Re: Chevron Service Station No. 9-1153
3135 Gibbons Drive (3126 Fernside Blvd)
Alameda, CA

Re: Modified Work Plan Addendum
Former Chevron Service Station 9-1153
3135 Gibbons Drive (3126 Fernside Blvd.)
Alameda, California
Fuel Leak Case No. RO0000341

Subject: Modified Work Plan Approval; Fuel Leak Case No. RO0000341; (Global ID # T0600100330);
Chevron #9-1153, (3126 Fernside Blvd), 3135 Gibbons Drive, Alameda, CA 94501

Figure 1
 SITEPLAN WITH PROPOSED BORING AND VAPOR LOCATIONS
 FORMER CHEVRON SERVICE STATION 9-1153
 3135 GIBBONS DRIVE (3126 FERNSIDE BLVD)
 Alameda, California

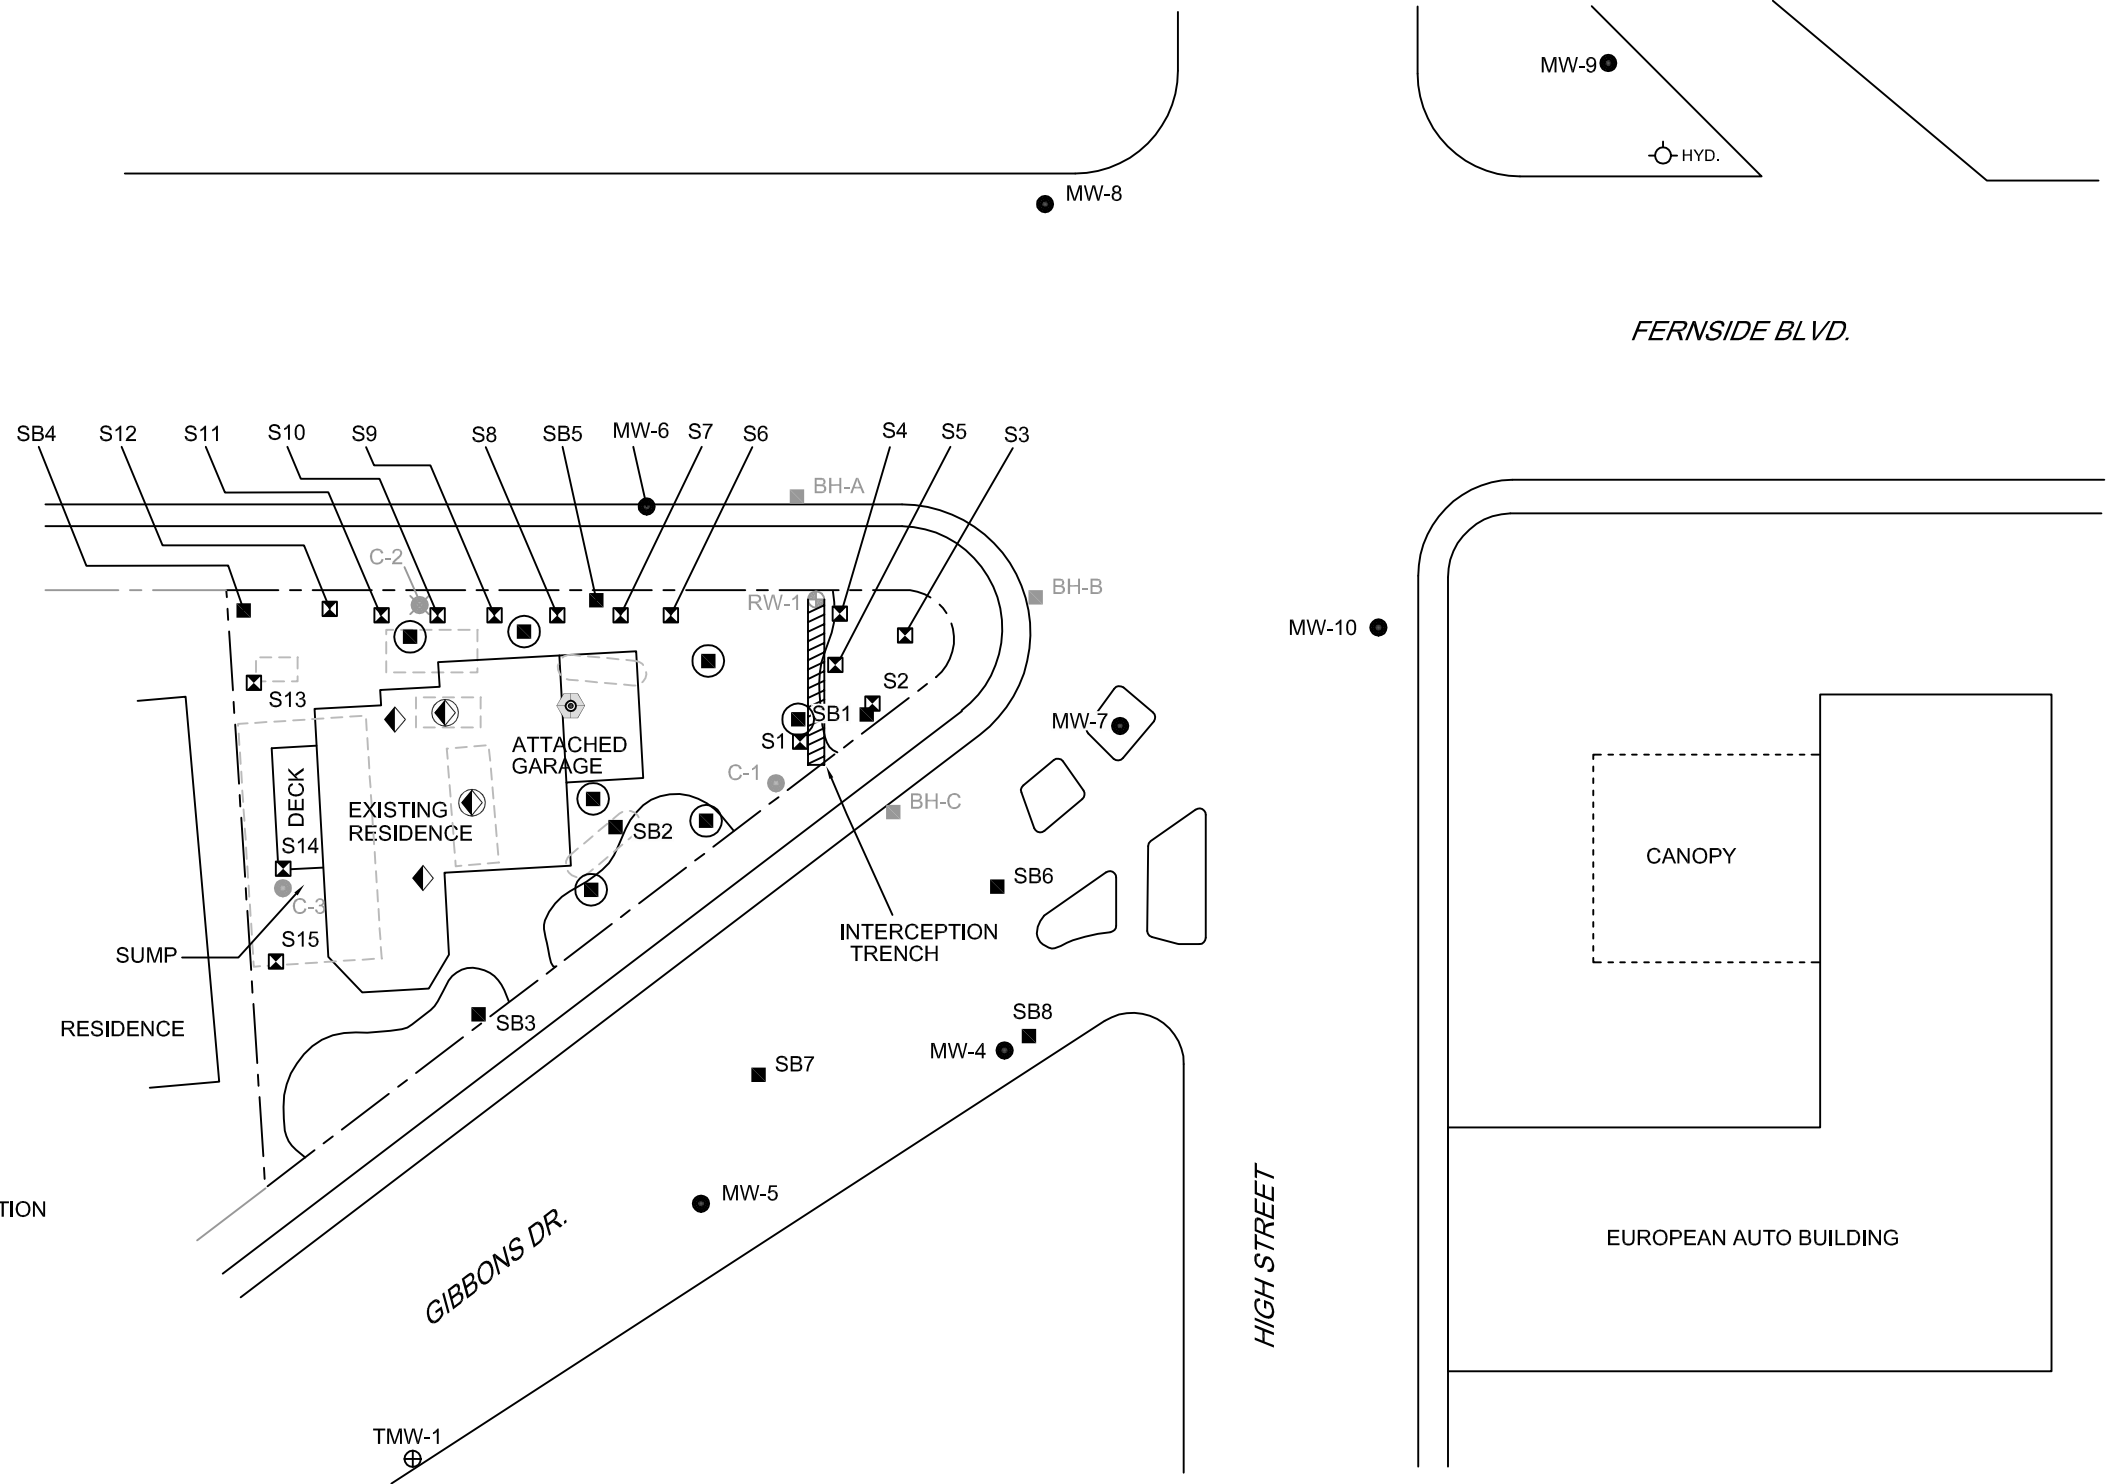
- 1. Vapor Intrusion Sampling** – The work plan proposes the collection of one sample in three locations as outlined above; however, because of site logistics (difficulty in accessing for UST excavation locations currently situated beneath the residential home) ACEH is not certain that one sample in the crawl space area will generate a representative sampling event. As a consequence, ACEH requests the collection of two crawl space vapor samples in an attempt to provide additional data to allow a better judgment of crawl space vapors. Collection of the crawl space samples should be positively biased to be collected vertically over the location of the former UST locations beneath the house. For similar reasons, ACEH is also uncertain that one indoor air sample will be adequate to understand the indoor air environment (due to common use of petrochemicals in consumer products). As a consequence, ACEH requests the collection of two indoor air samples, one in a worst-case and one in a best-case location. ACEH is in general agreement that one onsite outdoor air sample should adequately characterize the onsite outdoor air. By the date identified below, please convey to ACEH the proposed sample locations for each area with a rationale of the sample selection criteria. Please include in this information the location of the crawl space access door.

- 2. UST Backfill Soil Sampling** – Seven hand augered soil bores are proposed for installation to further investigate residual soil contamination in and in proximity to the former UST locations for reasons expanded on the previous directive letter dated March 3, 2011. ACEH is concerned sample collection, as proposed,

from a hand auger "bucket" will not allow the collection of representative samples; please utilize a slide hammer with a soil core sampler to ensure collection of representative soil samples. With respect to the analytical suite proposed for soil samples, please additionally submit samples for EDB and EDC; and TPHd and TPHmo (or a fingerprint analysis) due to the former presence of a waste oil UST at the site, and the apparent non-discriminate backfilling techniques. Finally, by the date identified below please convey to ACEH the location of the crawl space access door. If appropriately placed, please utilize this location to install an additional soil bore beneath the house through or in proximity to a former UST location.

As requested, CRA proposes to collect two ambient air samples within the crawl space above the former underground storage tank (UST) locations (Figure 1). These sampling locations are dependent on accessibility within the crawl space.

Two indoor ambient air samples are proposed within the house and will be collected in areas above the former USTs. These sampling locations will be in close proximity to the proposed ambient crawl space sample locations (Figure 1).

CRA will attempt to collect soil samples at the crawl space access door (Figure 1). These soil samples will be collected utilizing the same methods described in CRA's *Work Plan for Subsurface and Ambient Air Investigation* dated June 10, 2011 with the exception that the soil samples will be collected with a slide hammer lined with clean sample sleeves.

As requested, all soil samples will be collected utilizing a slide hammer and analyzed for total petroleum hydrocarbons as motor oil and total petroleum hydrocarbon as diesel by EPA Method 8015, and 1,2 dibromoethane and 1,2 dichloroethane by EPA Method 8260.
